Addendum No. 1

Project: North Carolina State University
Textiles Complex
Flex Factory Renovations
Raleigh, NC 27607

ADDENDUM 01

Project: NCSU – Textiles Complex – Flex Factory Renovations
SCO ID#: 23-26253-01A
NCSU Project ID: 202220031
Date: June 16, 2025

2 MECHANICAL PIPING - NEW WORK - MEZZANINE
1/8" = 1'-0"

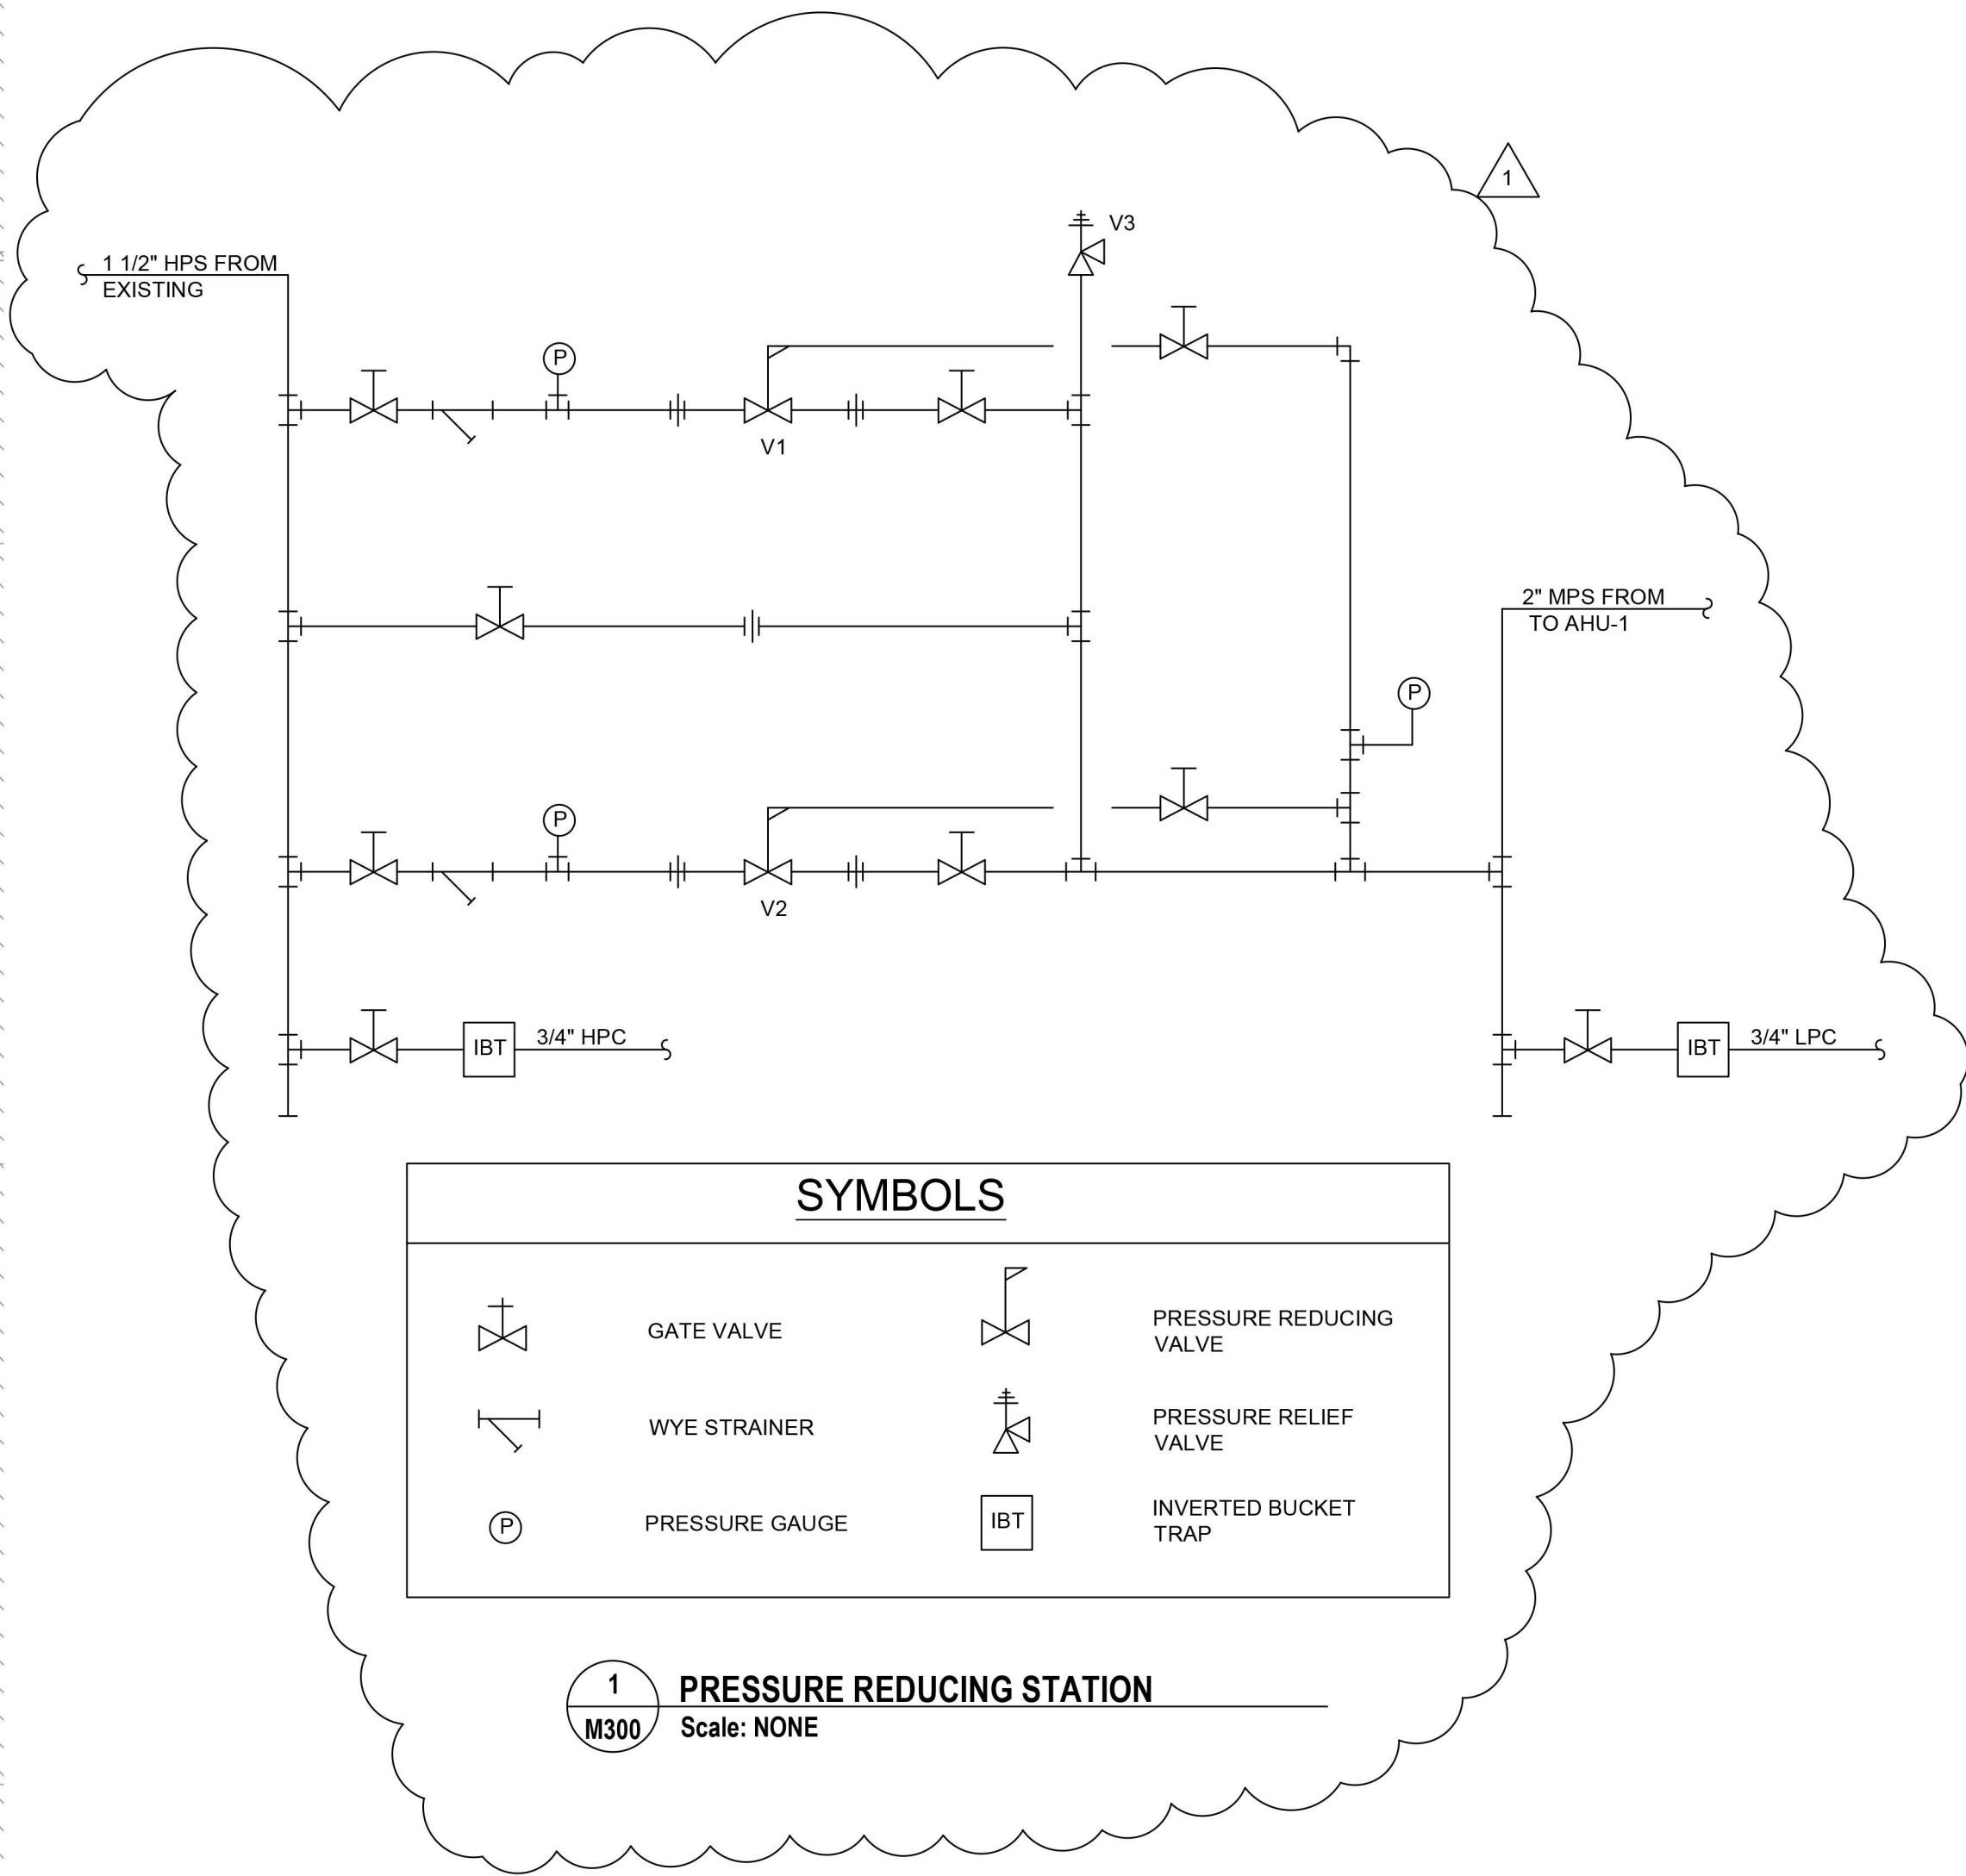
- RFI No. 007 The steam piping going to AHU-1 is labeled as HPS (high pressure steam), is this correct and if so, what is the steam pressure, the heating coil on the AHU-1 schedule is only rated for 10psi?*

Response: Provide steam pressure reducing station as indicated in the revised sheets M002, M210, M300.
- RFI No. 008 Is there another time that a walk-thru would be possible?*

1 FLOOR PLAN - ENTRY LEVEL AREA 1
1/8" = 1'-0"

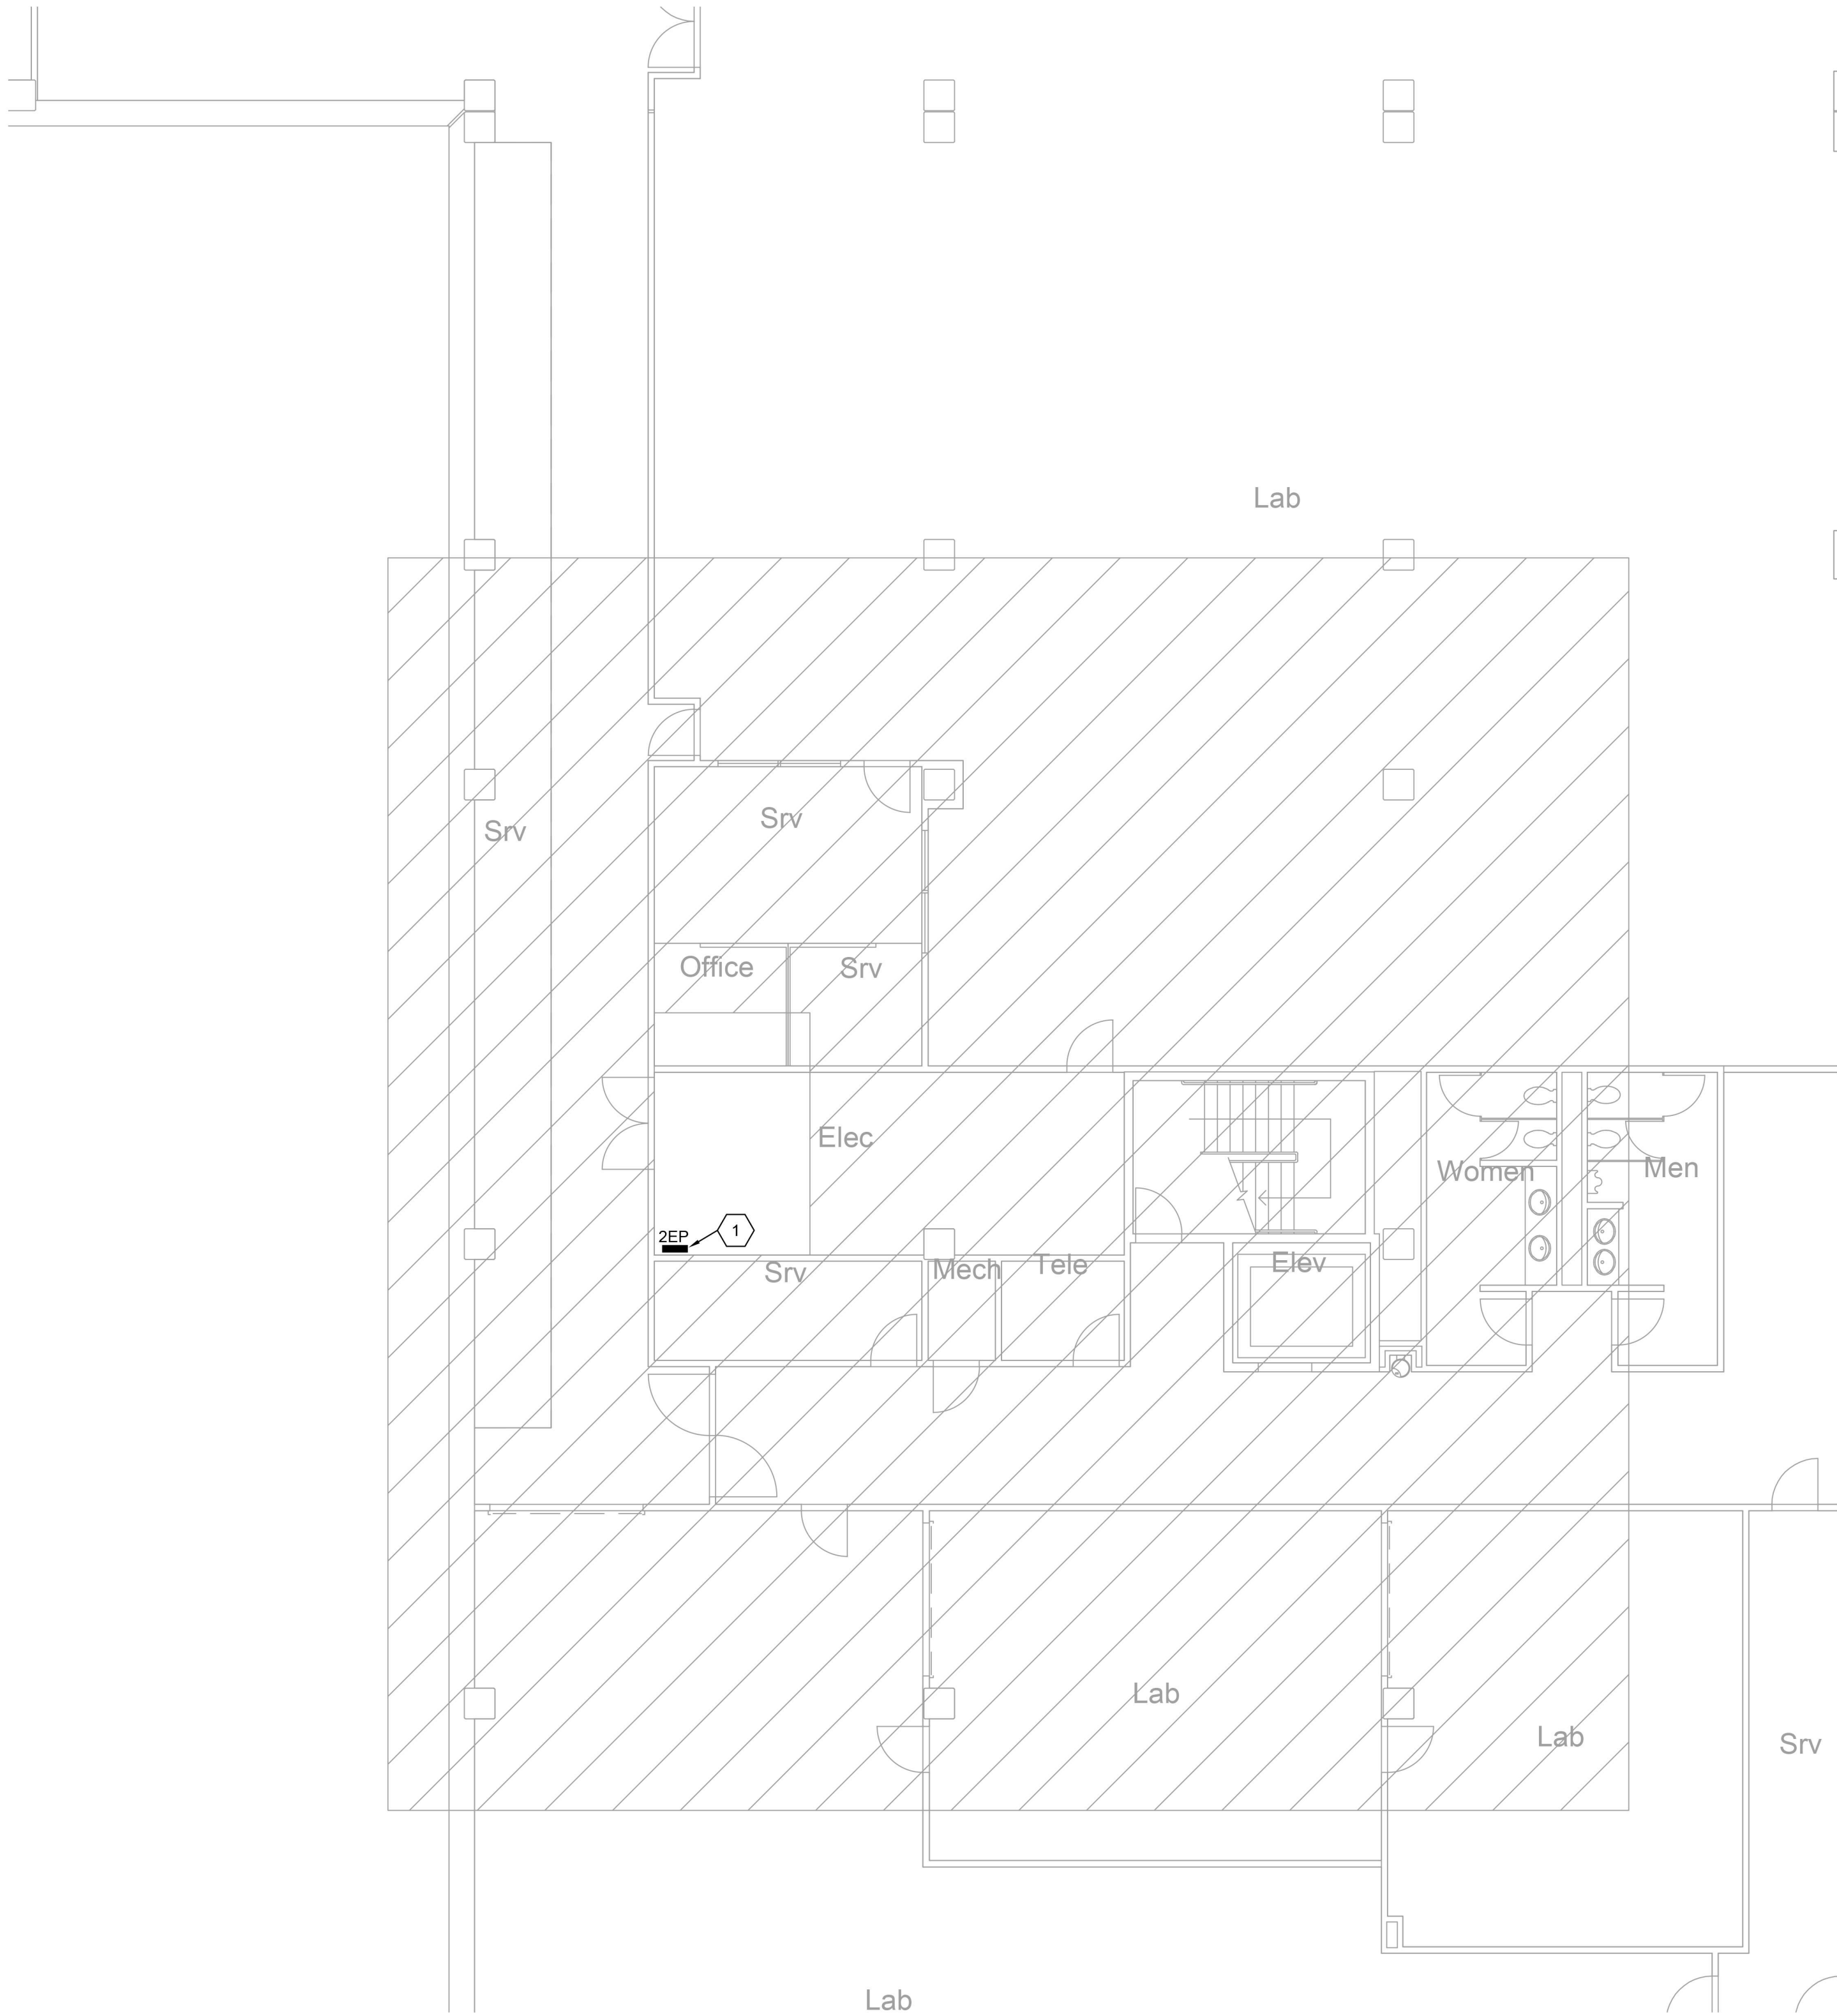
Response: See General Scope Item Nos. 6 & 7 in I.L. Long Construction's Bid Package Manual.
- RFI No. 040 *See attached sheets. Confirm marked up G007 is where panel 2EP is located. Page E108, do we have an overall plan showing note 1&2 location?*

Response: Refer to the revised sheets E108 and E109 issued in this addendum.
- RFI No. 041 *Is there a specification for the emergency light to apply to Unit Price E2?*
